SUBDIVISION REPORT - CONCEPT/USE ON REVIEW

► **FILE #:** 1-SC-20-C
1-E-20-UR

► **SUBDIVISION:** STEELE LANDING

► **PROPOSED USE:** Attached Residential Subdivision

LAYOUT AND PAVING PLAN

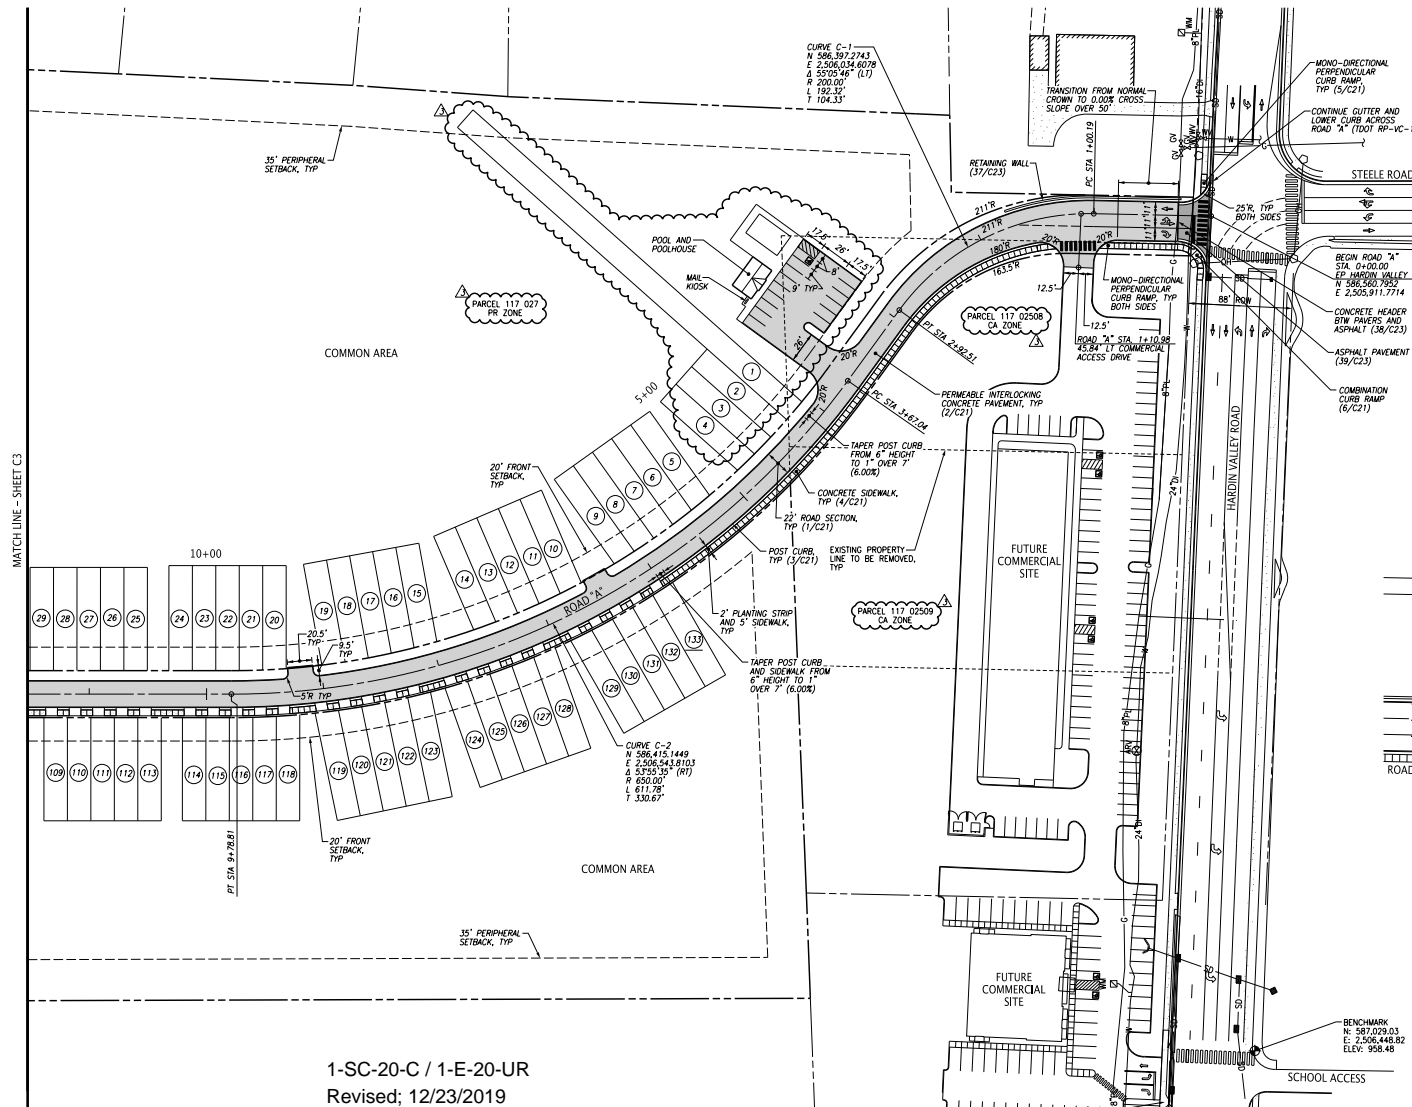
1. Reduce the intersection radii for the right-of-way for Road A at Hardin Valley Rd., from 75' to 0'.
2. Reduce minimum horizontal curve radius from 250' to 150' for Road "A" from STA 1+00.19 to STA 2+92.51.
3. Reduce minimum horizontal curve radius from 250 ft to 150 ft for Road "A" from STA 13+47.12 to STA 15+82.74.
4. Reduce minimum K-value from K= 25 to K= 15 for Road "A" at STA 1+01.91.
5. Reduce minimum lot width from 25' to 20'.

The applicant has requested a variance from the Subdivision Regulations to reduce the minimum lot width for access from 25' to 20'. The proposed townhouse units would include a one car garage with a parking space in front of the garage. With the proposed site grading for the townhouse units and the reduced pavement width for the street, staff has expressed concern with the applicant that there may not be adequate parking for residents and guests on site.

- **APPROVE** variances 1-5 and waiver 1 because the site's topography and shape restrict compliance with the Subdivision Regulations and the proposed variances and waiver will not create a traffic hazard.

APPROVE the Concept Plan subject to 9 conditions.

5. Installation of sidewalks as identified on the concept plan. Sidewalks shall meet all applicable requirements of the Americans with Disabilities Act (ADA) and the Knox County Department of Engineering and Public Works. A bond shall be provided to the Knox County Department of Engineering and Public Works by the developer in an amount sufficient to guarantee the installation of the sidewalks.
